**Information Request 24**

**Response to Information Request 24**

## **IR 24 – Fish Lake Control Dams**

EIS Appendix 2.2.5-A (Conceptual Design of Fish Lake Control Dams)

TASEKO MINES LIMITED	
NEW PROSPERITY GOLD-COPPER PROJECT	
<b>OPEN PIT BLASTING TYPICAL PEAK PARTICLE VELOCITY ESTIMATES</b>	
<i><b>Knight Piésold</b></i> CONSULTING	P/A NO. VA101-266/30
	REF. NO. VA13-00360
<b>FIGURE 24-1</b>	
	REV A

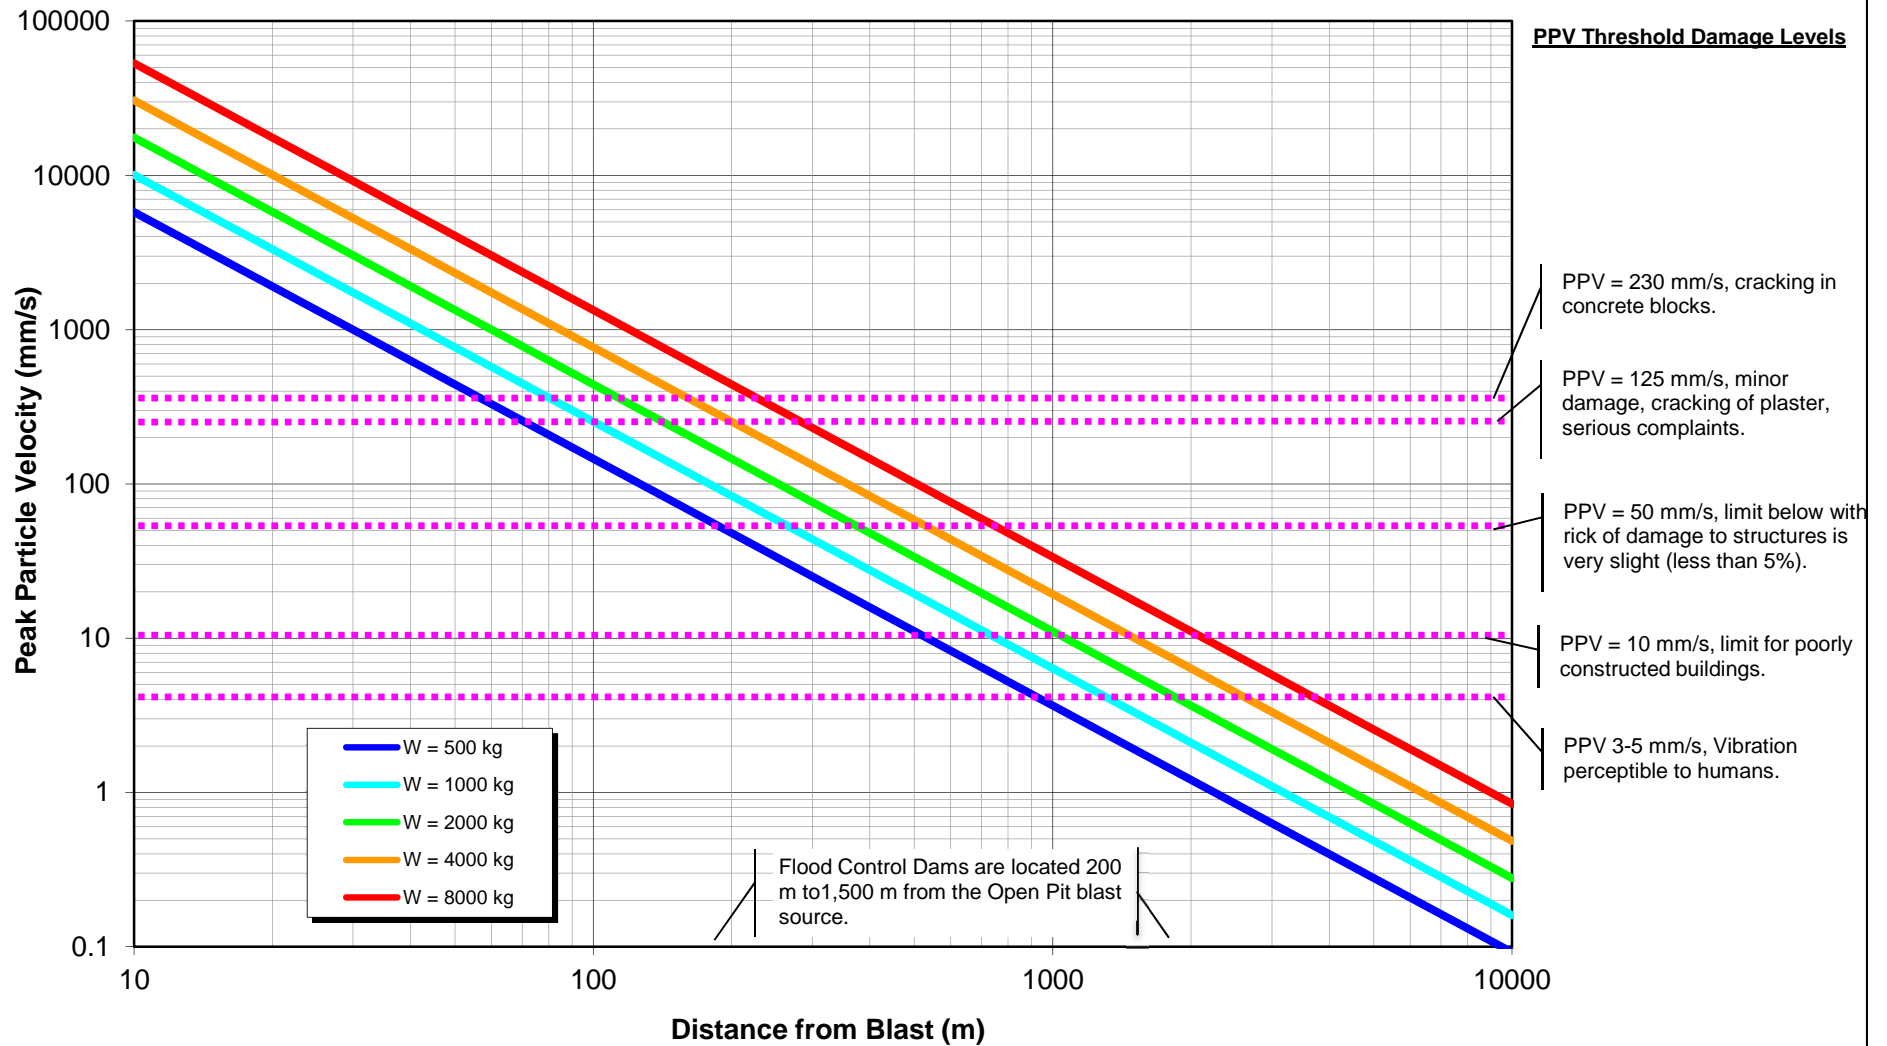
- a. Discuss what potential effects pit blasting may have on the Fish Lake control dams over the life of the mine and how the eventual design and construction will address these potential effects.

The FCD are currently designed as embankments of earth fill construction, located between 200 m to 1,500 m from the Open Pit blasts. The potential hazard to the FCD from blasting is due to blast energy transmitted to the structure (measured as peak particle velocity), the combination of distance from the Open Pit (the blast source), the FCD construction (which will be resistant to damage by blasting vibration) and the FCD foundation soils (which are competent non-liquefiable) are expected to result in acceptably low peak particle velocities at the FCD location.

An estimated peak particle velocity at the FCD for various charge weights is shown on Figure 24-1. This peak particle velocity estimate has been completed using assumed parameters for a typical production Open Pit blast. The estimated charge weight per delay from blasts in the New Prosperity open pit is 630 kg's. The maximum peak particle velocity of vibrations expected from this charge that is a distance of 200 meters from the FCD is 36 mm/second. The dams will be designed to not only withstand this vibration but will have a factor of safety intended to withstand much greater peak particle velocities.
